Mosqueda Community Center - Exterior  
4760 East Butler, Fresno

Mosqueda Community Center (MCC)

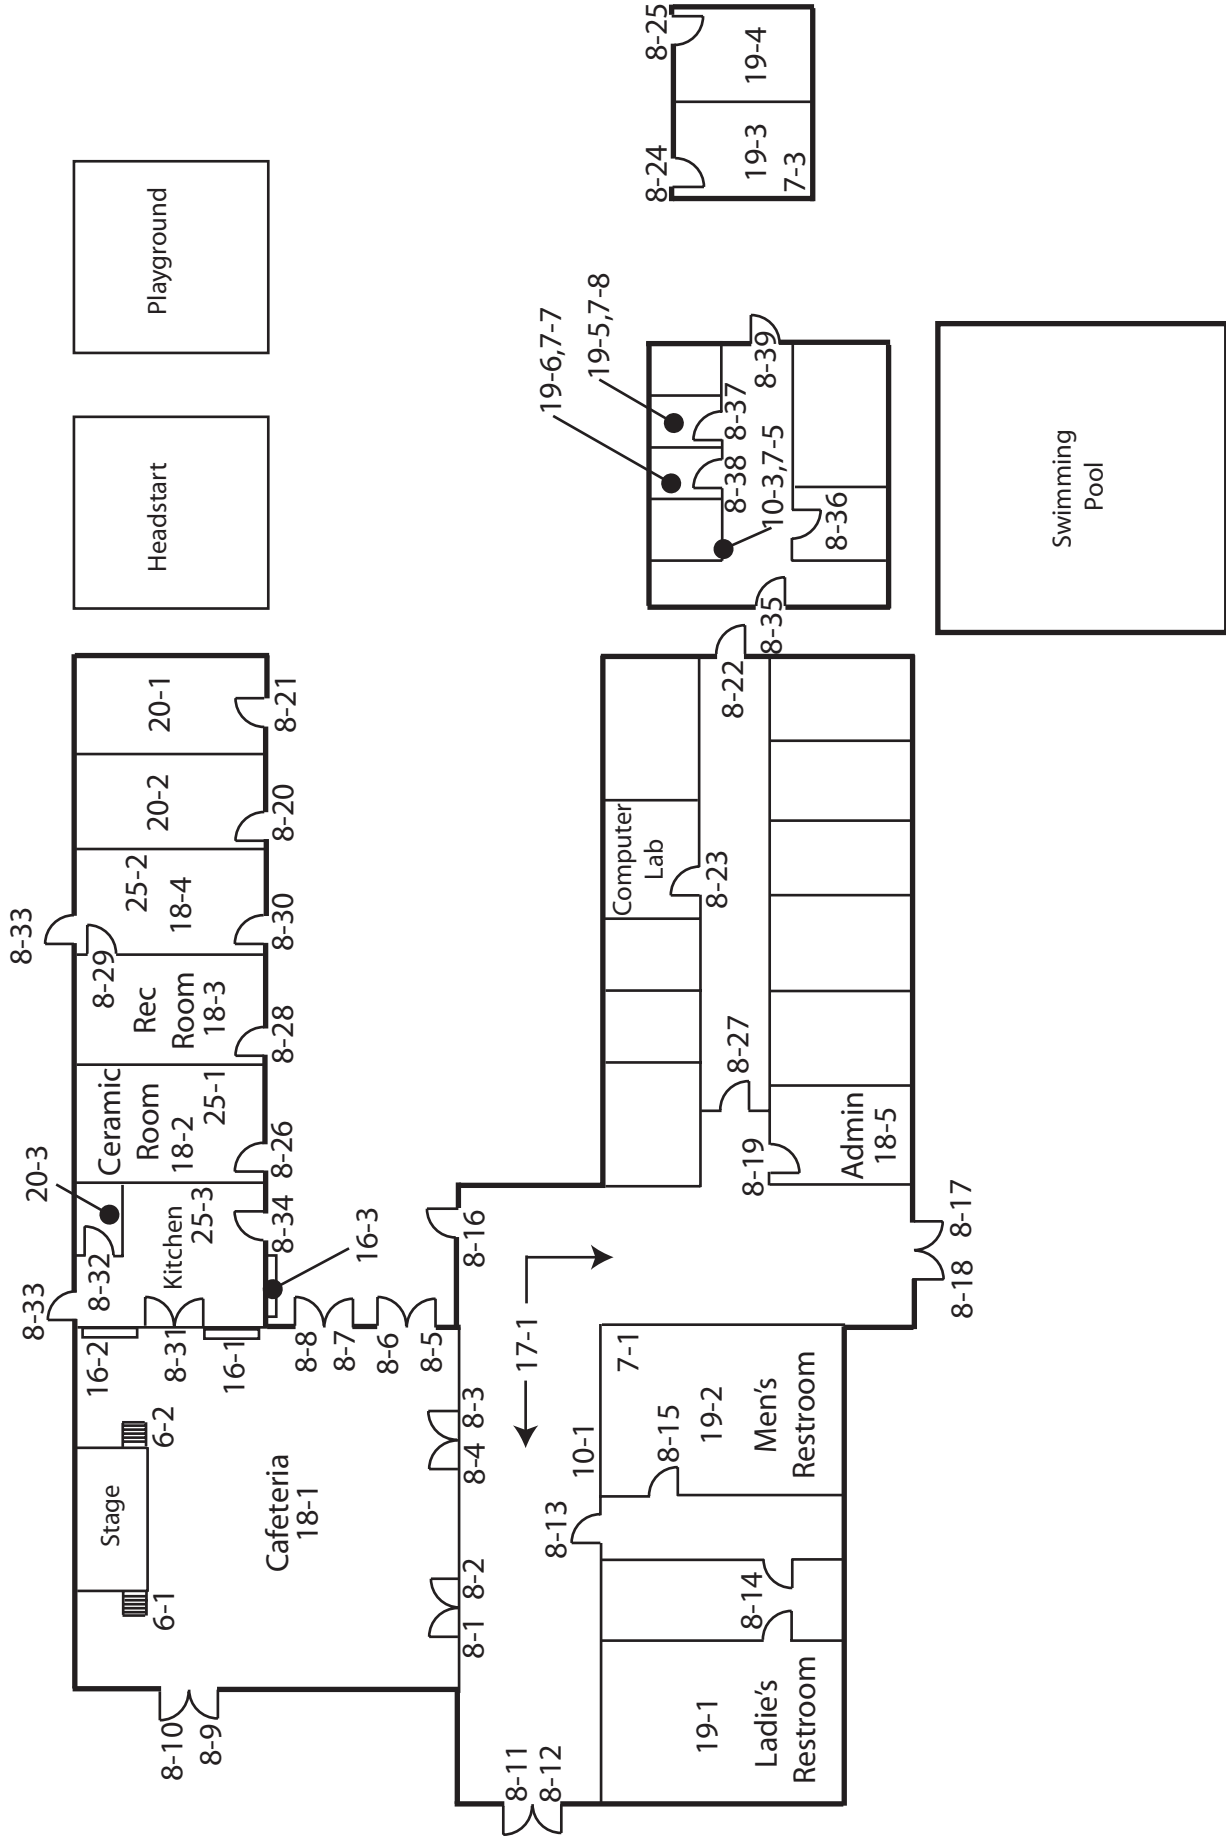
<b>Exterior</b>		
<b>6 - 3</b>	<b>Stairway</b>	Priority:2
<b>Install tread striping</b>		\$90
Notes: Indicator stripes are not provided.		
State: 1127B.4, 1133B.4.4		
Federal: -		
<b>Replace stairs</b>		\$2,250
Notes: Width of stairs are 36" (44" min).		
State: 1007.3, 1009.1		
Federal: -		
<b>Install or modify handrails</b>		\$0
Notes: Handrail diameter is 2" (1-1/4" to 1-1/2"). Handrail is 2-1/4" (1-1/2") from the wall. Handrails with continuous gripping surfaces are not provided. Extensions at the bottom of the stair run are not provided.		
State: 1133B.4.1.1, 1133B.4.2.2, 1133B.4.2.5, 1133B.4.2.6		
Federal: 4.26.2, 4.9.4, 4.9.4 #2, 4.9.4 #3		
<b>6 - 4</b>	<b>Stairway</b>	Priority:2
<b>Install tread striping</b>		\$90
Notes: Indicator stripes are not provided.		
State: 1127B.4, 1133B.4.4		
Federal: -		
<b>Replace stairs</b>		\$2,250
Notes: Width of stairs are 36" (44" min).		
State: 1007.3, 1009.1		
Federal: -

<b>Install or modify handrails</b>		\$2,000
Notes: Handrails with continuous gripping surfaces are not provided. Extensions at the bottom of the stair run are not provided. Handrail diameter is 2" (1-1/4" to 1-1/2"). Handrail is 2-1/4" (1-1/2") from the wall.		
State: 1133B.4.1.1, 1133B.4.2.2, 1133B.4.2.5, 1133B.4.2.6		
Federal: 4.26.2, 4.9.4, 4.9.4 #2, 4.9.4 #3		
<b>7 - 2</b>	<b>Hazard</b>	Priority:2
<b>Remove overhanging or protruding objects</b>		\$750
Notes: Drinking fountain protrudes 12" (4" max) and is 33-1/2" (not between 27" to 80") above the finished floor. Provide wing walls.		
State: 1133B.8.6.1		
Federal: 4.4.1

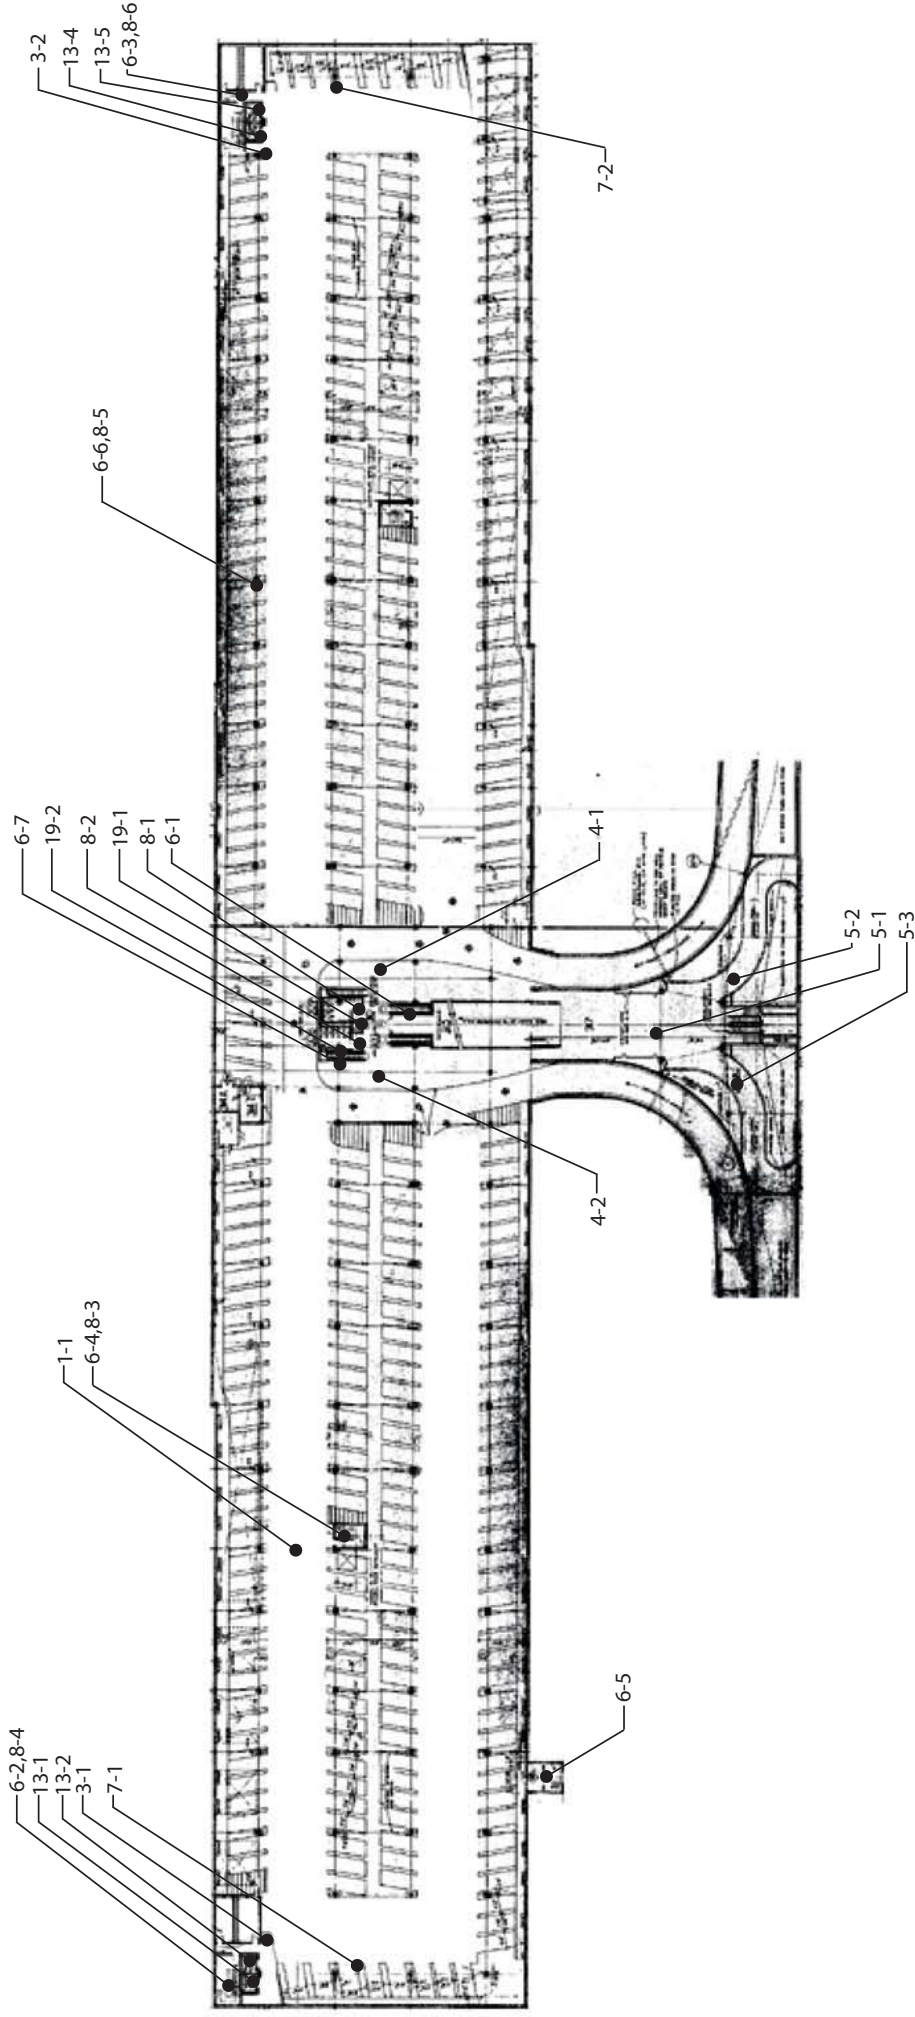
<b>Floor Blue</b>	
<b>1 - 1</b>	<b>Parking Area</b> <span style="float: right;">Priority:2</span>
<b>Provide or modify accessible access aisles</b>	<b>\$900</b>
Notes: There are 6 accessible parking stalls that do not provide access aisles.	
State: 1129B.3 #1, 1129B.3 #2, 1129B.4 #1	
Federal: 4.6.3	
<b>Install van parking sign</b>	<b>\$250</b>
Notes: Van accessible parking sign is not provided.	
State: 1129B.4	
Federal: 4.6.4	
<b>Install sign</b>	<b>\$750</b>
Notes: The words 'NO PARKING' are not painted in the access aisles.	
State: 1129B.3 #1, 1129B.3 #2	
Federal: -	
<b>Provide an accessible path of travel</b>	<b>\$2,000</b>
Notes: Wheelchair users are required to walk behind other parked vehicles in order to access path of travel.	
State: 1129B.3 #3	
Federal: -	
<b>Provide or modify accessible spaces</b>	<b>\$500</b>
Notes: Stall length is 16' (18' min) for 2 accessible parking stalls.	
State: 1129B.4 #1

Federal: 4.6.3	
<b>Regrade surface</b>	<b>\$1,800</b>
Notes: Slope for one accessible parking stall is 2.5% (2% max).	
State: 1129B.3 #4	
Federal: 4.6.3	
<b>Provide or modify accessible spaces</b>	<b>\$100</b>
Notes: The International Symbol of Accessibility painted in 2 accessible parking stalls are incorrect.	
State: 1129B.4	
Federal: 4.6.4	
<b>Provide or modify accessible spaces</b>	<b>\$5,100</b>
Notes: There is a total of 333 parking stalls. Out of the 333 stalls, 6 accessible parking stalls are provided. A total of 8 accessible parking stalls are required.	
State: 1129B	
Federal: 4.1.2(5)(b)

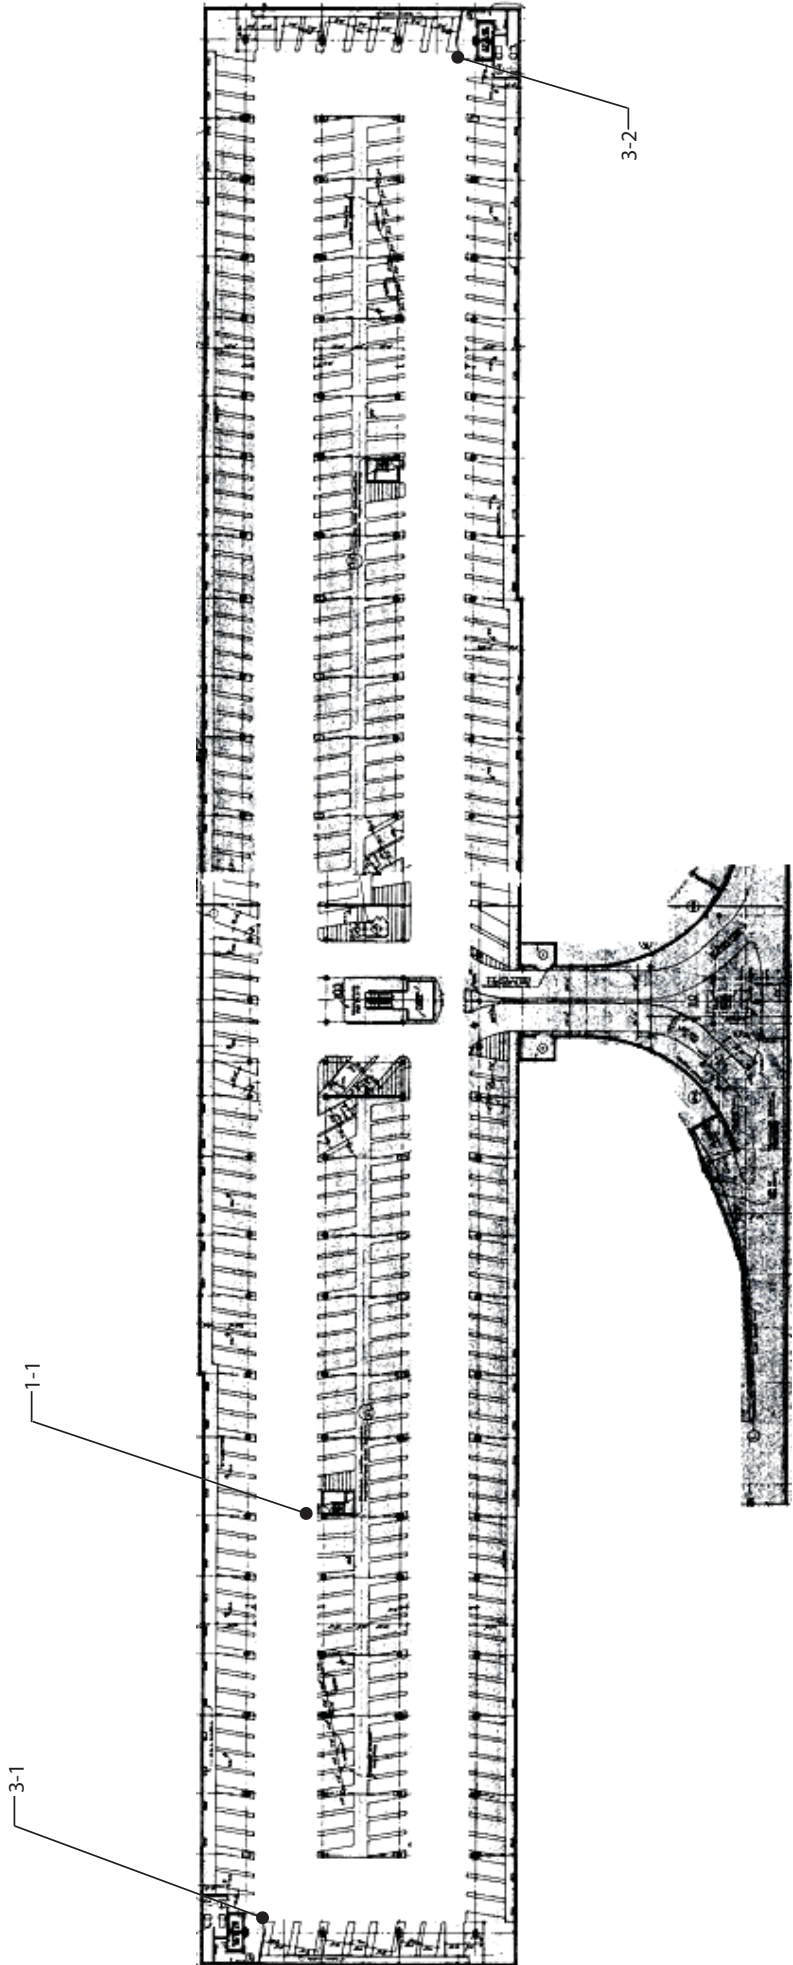
<b>Floor Green</b>	
<b>19 - 2 Multiple User Restroom</b>	<b>Priority:2</b>
<b>Install sign</b>	<b>\$250</b>
Notes: Federal required signage is not located on the latch side of the door.	
State: 1115B.6, 1117B.5.1 #1	
Federal: 4.30.4	
<b>Replace or reposition dispensers or mirrors</b>	<b>\$200</b>
Notes: Mirror is mounted so bottom of reflecting surface is 48" (40" max) above the finished floor.	
State: 1115B.8.1	
Federal: 4.19.6	
<b>Modify lavatory/counter clearances</b>	<b>\$3,500</b>
Notes: Clear space beneath the lavatory sink is 27-3/4" (29" min) high. The space under the bowl is 25" (27" min) when measured 8" in from the front edge.	
State: 1115B.4.3 #2	
Federal: 4.19.2	
<b>Insulate water lines</b>	<b>\$100</b>
Notes: Hot water and drain pipes are not insulated.	
State: 1115B.4.3 #4	
Federal: 4.19.4	
<b>Provide or replace stall door hardware</b>	<b>\$200</b>
Notes: Stall door does not have U-shaped handles on the front or back.

State: 1115B.3.1 #4.5	
Federal: 4.13.9	
<b>Modify stall partitions and doors</b>	<b>\$800</b>
Notes: Door width is 23" (32" min) for end-entry stall.	
State: 1115B.3.1 #4.4	
Federal: -	
<b>Replace or reposition fixtures</b>	<b>\$1,000</b>
Notes: Clear space from the wall to the centerline of the toilet is 17-1/4" (18" req).	
State: 1115B.7.1.3	
Federal: 4.17.3	
<b>Modify stall partitions and doors</b>	<b>\$500</b>
Notes: Clear space from the edge of the toilet to the fixture is 10" (32" min).	
State: 1115B.4.1 #1	
Federal: 4.17.3
